**NUMBER:** 07-001-13

Whine, Howl, and/or Humming Noise At Speeds Below 30 mph (48 kph) With Engine Speeds Between 1200 - 1500 RPM

This bulletin involves installing an insulating package onto the transmission cooler lines.

Fig. 1 Foam Sleeve Kit Installation

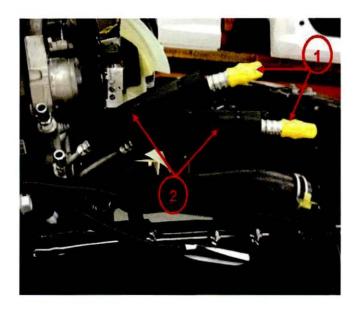
1. Install one foam sleeve (from kit p/n 68217310AA) on each cooler line between the metal crimp fittings as shown in (Fig. 1). Ensure that the foam slit is facing downward.

2. Secure the foam sleeve with the three (3) tie straps. Tighten the tie strap just enough to secure the sleeves in place.
